<b>APPLICATION NUMBER:</b>	PLN-26-028
<b>PROPOSED DEVELOPMENT:</b>	Addition to existing multiple dwelling
<b>LOCATION:</b>	8A Chestnut Avenue Lutana
<b>APPLICANT:</b>	G O'Halloran
<b>ADVERTISING START DATE:</b>	18/04/2026
<b>ADVERTISING EXPIRY DATE:</b>	02/05/2026

**PLANNING APPLICATION – 8A CHESTNUT AVE, LUTANA**  
**DWELLING ALTERATIONS AND ADDITIONS; APPLICATION NO: PLN-26-028**

Further to your request for additional information regarding this application, we provide the following responses and the revised drawings Ap01.A to Ap05.A attached:

PROJECT No. 25.257 DRAWING No. Ap100 REV. 001

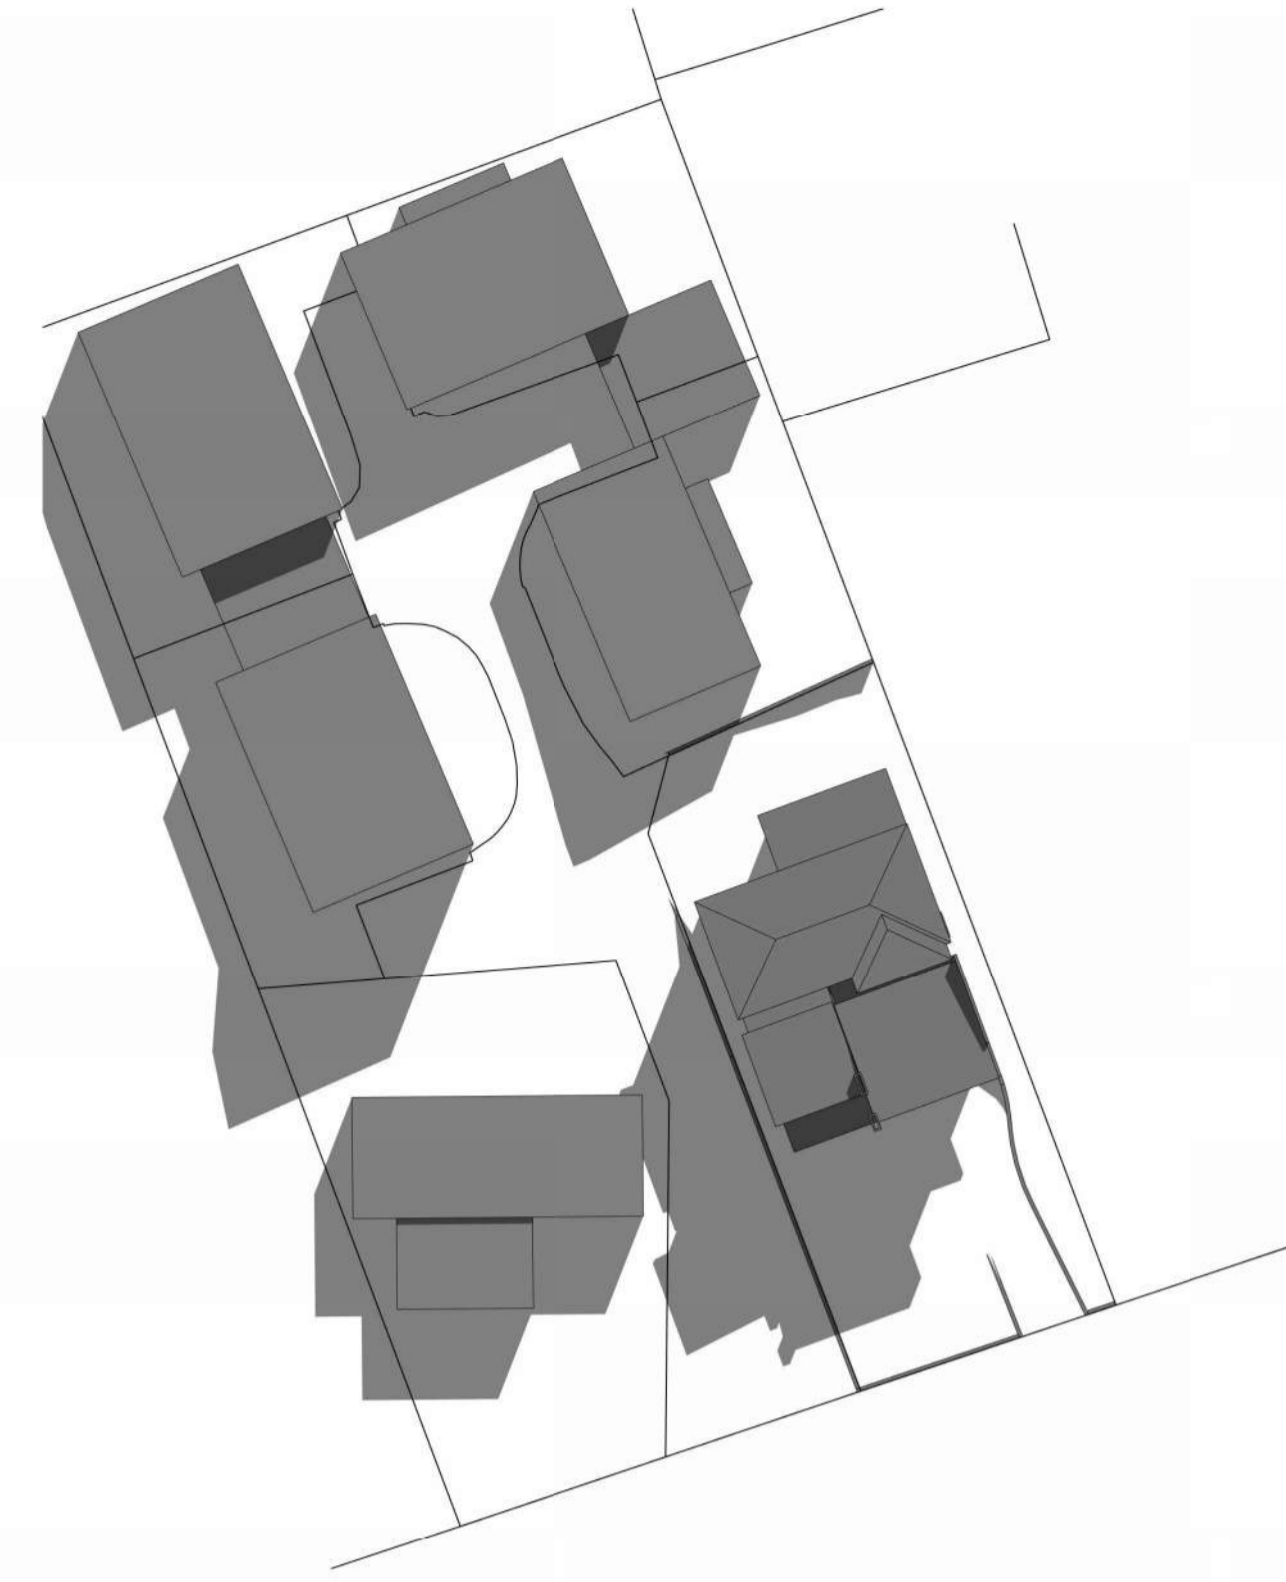
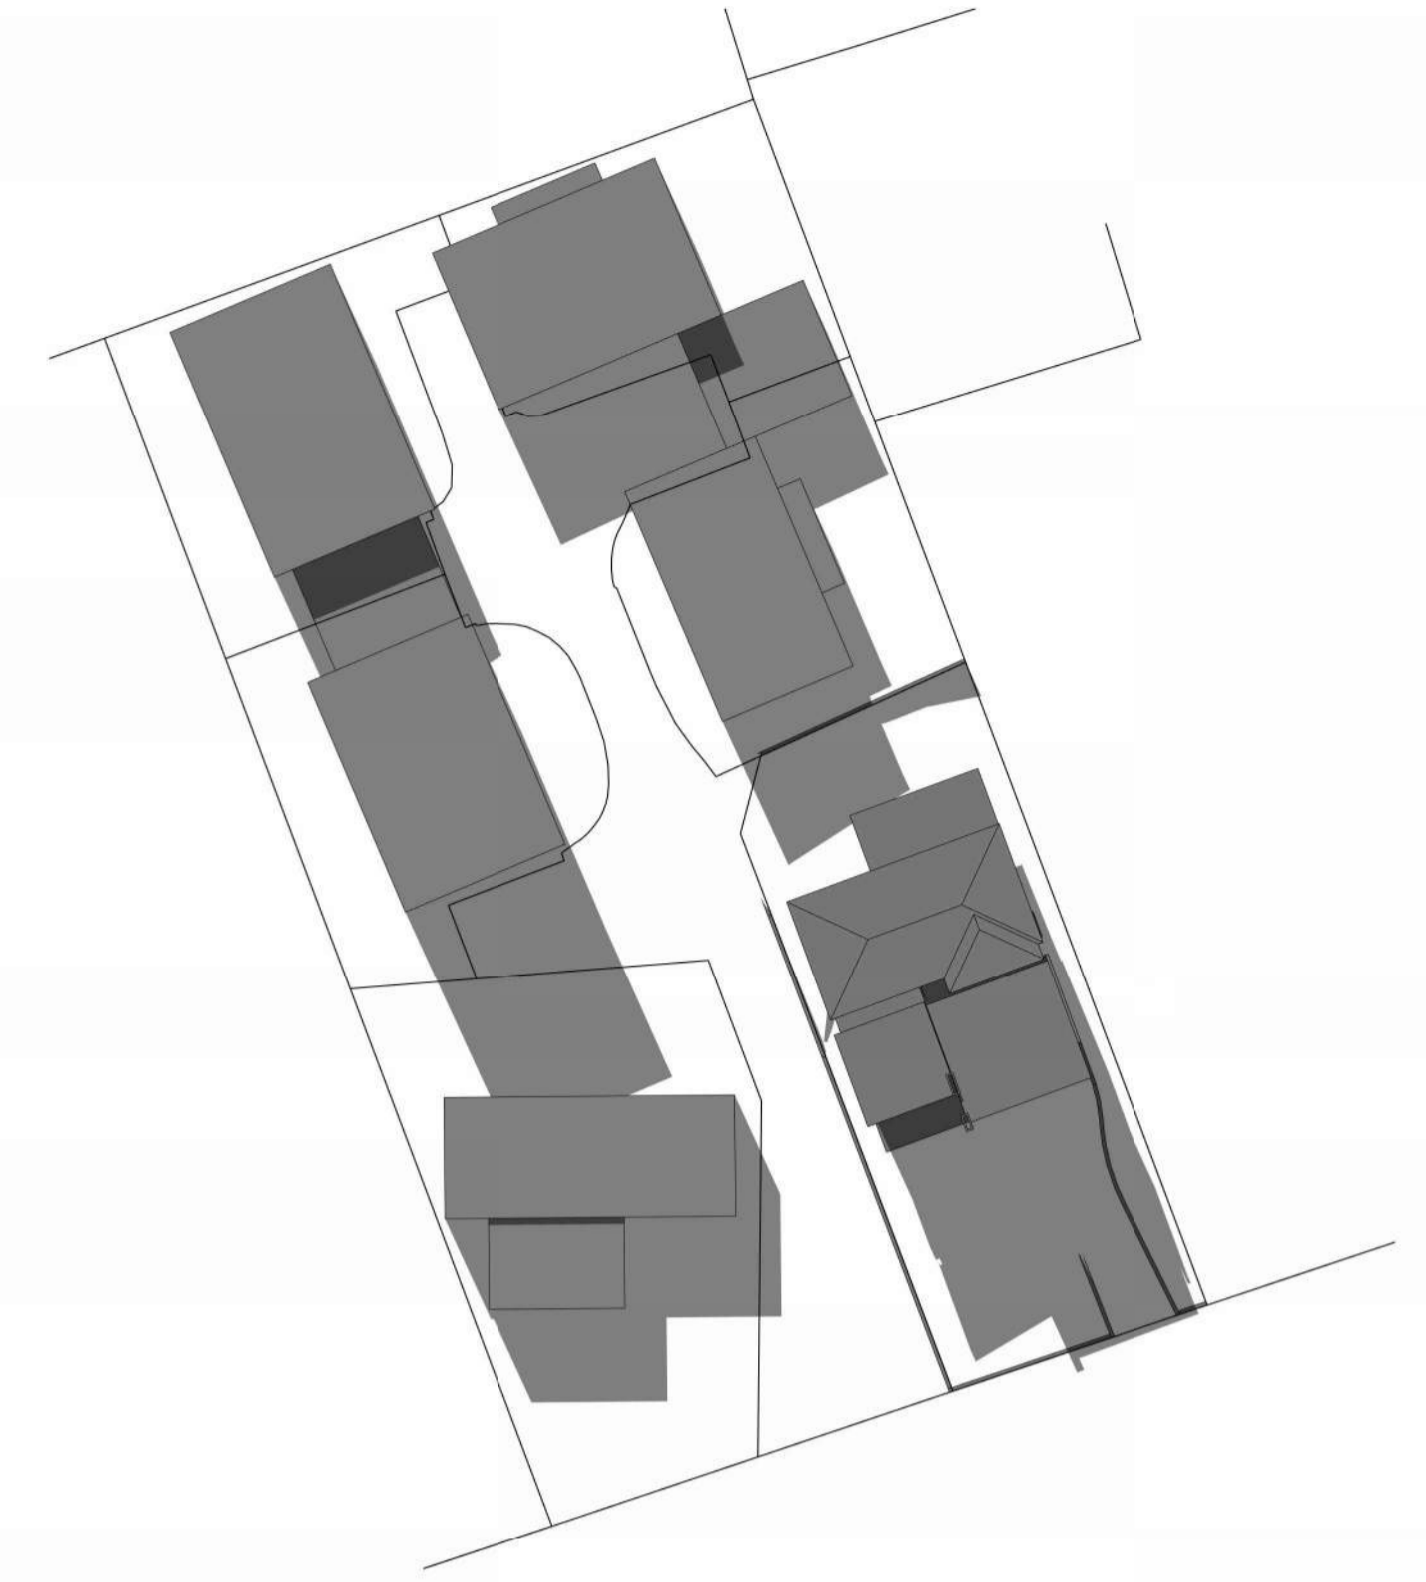
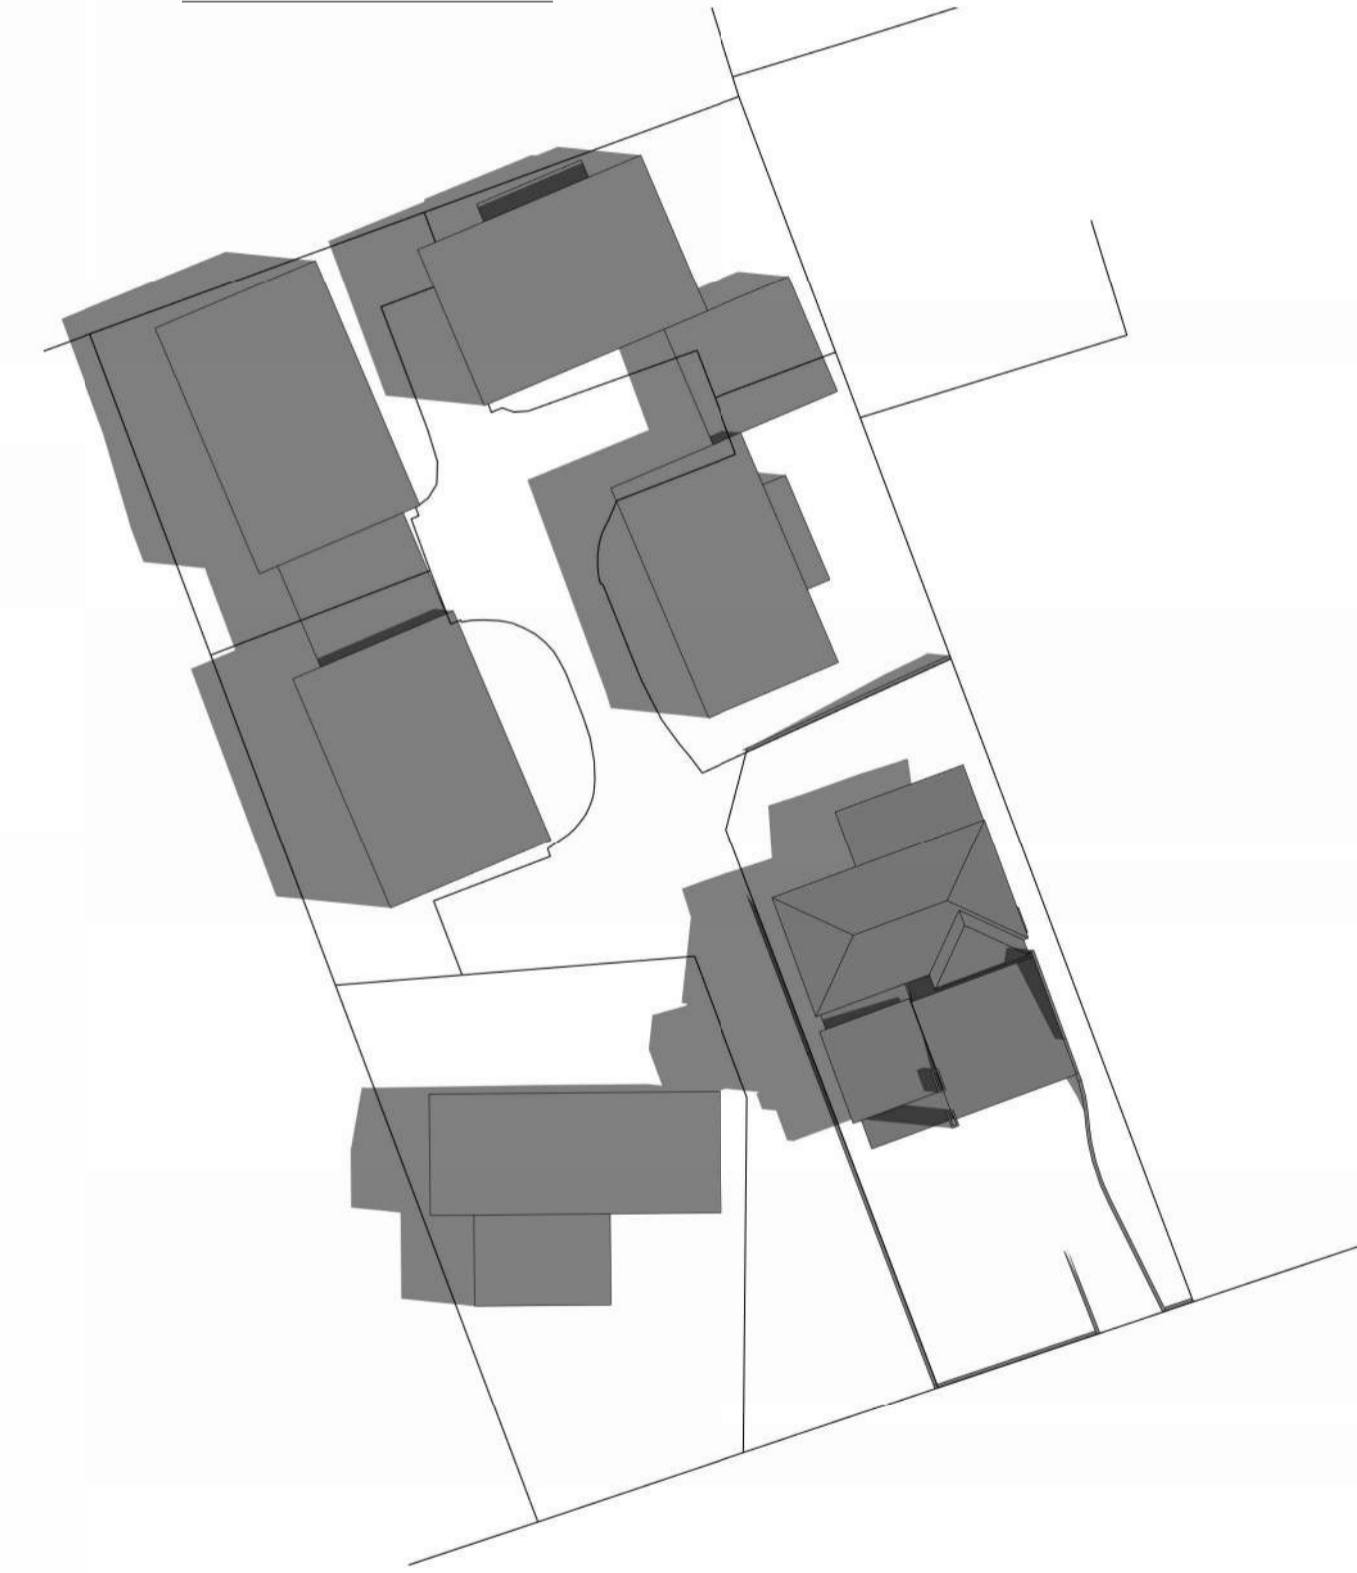
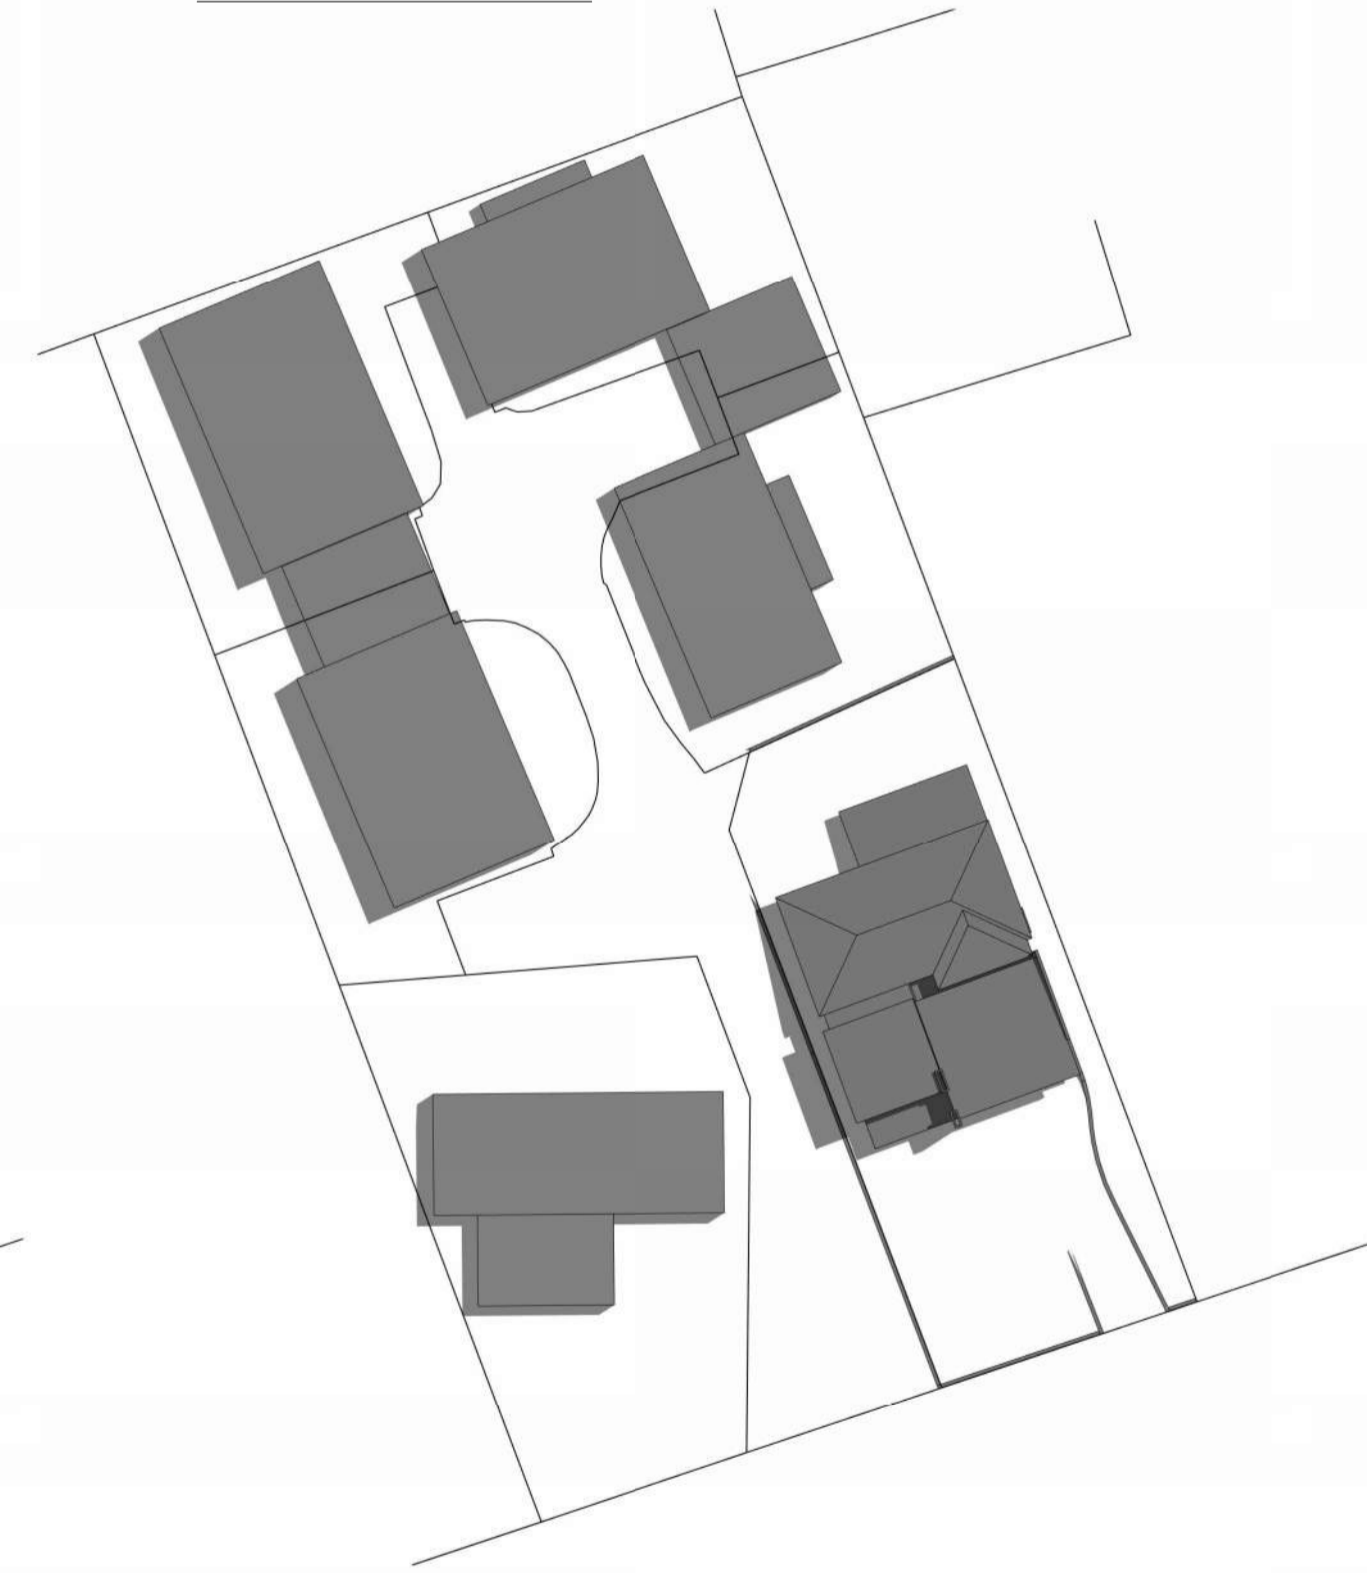
*Please fully address visual impact from the view of the adjacent property at 10 Chestnut Avenue with respect to bulk and scale. Whilst it is appreciated that the proposed height might not be out of place within the general area, the proposal is not in accordance with the minimum setback. The acceptable solution allows a height of 4.5m at the 1.5m setback mark. The acceptable solution requires a minimum setback of 1.5m, unless the building is less than 9m in total length. The total length within the minimum setback margin of the east elevation is more than 16m. This does also not appear consistent with that of existing in the area. Most dwellings in the area, except for outbuildings and small sections, appear to have a minimum side setback of 1.5m.*

Refer to drawing Ap100 Shadow Diagrams for evidence that overshadowing will be negligible in mid-summer and not relevant at all for most of the year.
